Standards Support and Environmental Impact Statement Volume II: Promulgated Standards of Performance for Petroleum Refinery Sulfur Recovery Plants

EPA-450/2-76-016-b
January 1978

Petroleum Refinery Sulfur Recovery Plants

Figure 2.1. Incremental Annual Cost vs. Plant Capacity

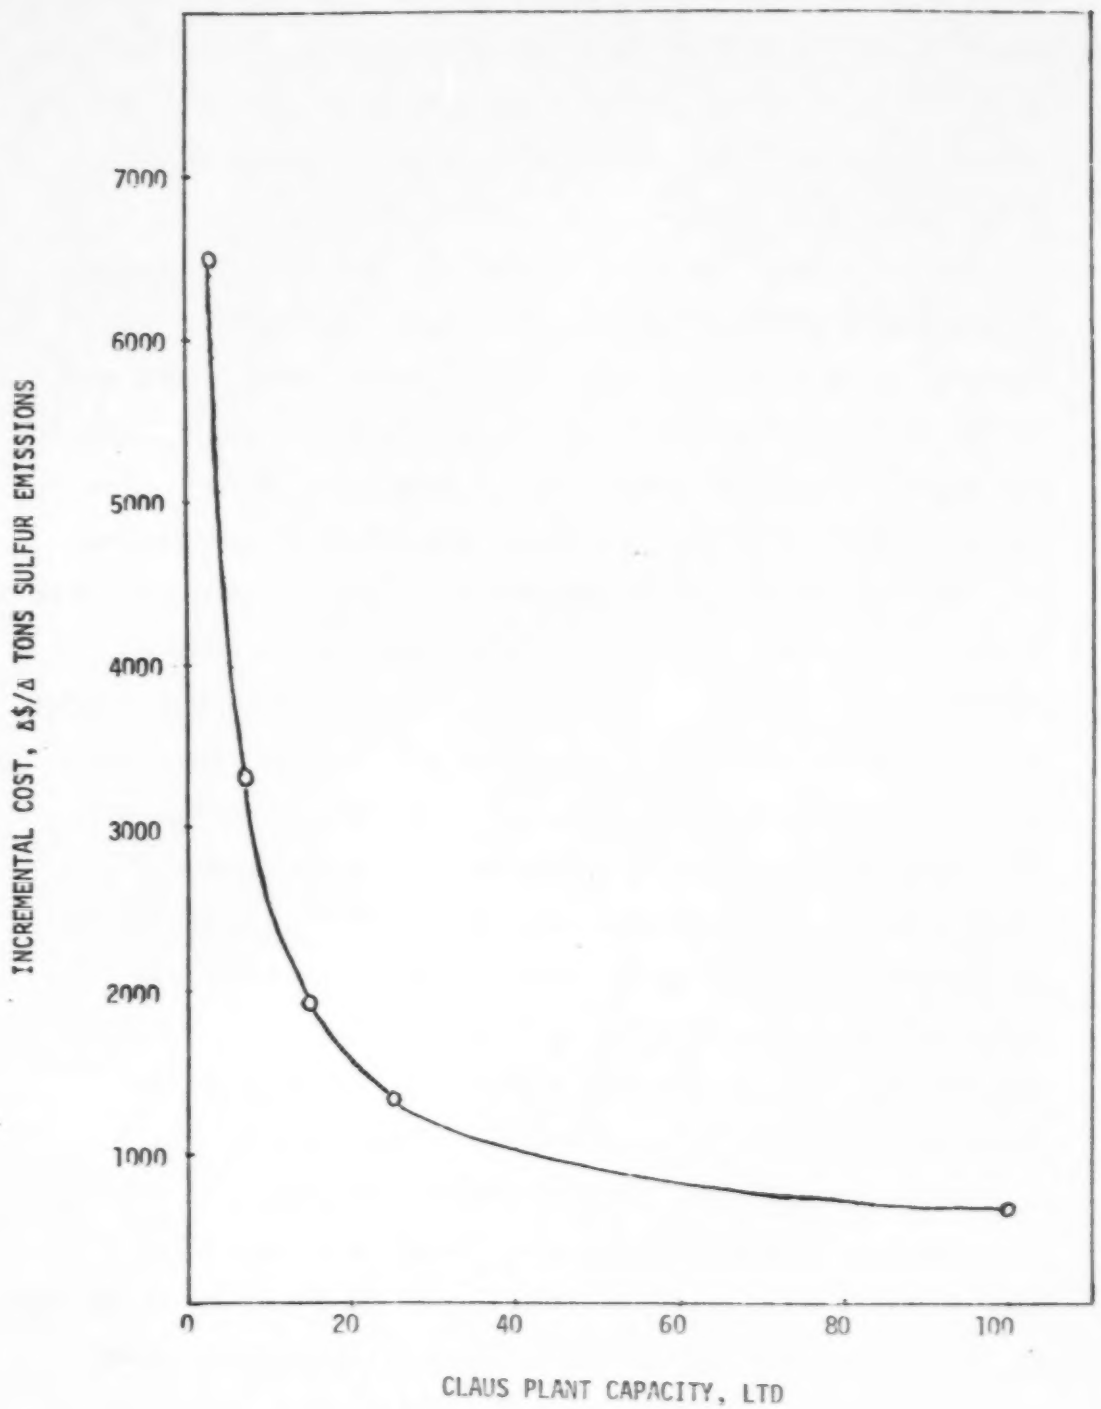
Several commenters, including a State air pollution control agency, recommended an exemption from the standard for small petroleum refineries and/or petroleum refineries which install small Claus sulfur recovery plants. These commenters felt that the cost impact of the standard on small petroleum refineries would be extremely burdensome, compared to the cost impact on large petroleum refineries. They also felt that an exemption for the small refiner would not have a significant adverse environmental impact since the small refiner represents only a small segment of total domestic petroleum refining capacity. Several of the commenters suggested that a standard covering all new petroleum refinery Claus sulfur recovery plants could actually have a negative environmental impact since this standard would discourage the installation of sulfur recovery plants at petroleum refineries in those few cases where these plants are not already required by existing State air pollution regulations.

Figure 2.1 was the basis for selecting 20 LTD as the cut-off point for exempting small Claus sulfur recovery plants from compliance with the standard. As shown by this figure, for Claus sulfur plants of less than 20 LTD, the "cost effectiveness" of alternative emission control system II over alternative emission control system I deteriorates rapidly. Thus, this is the most reasonable point for an exemption to become effective.
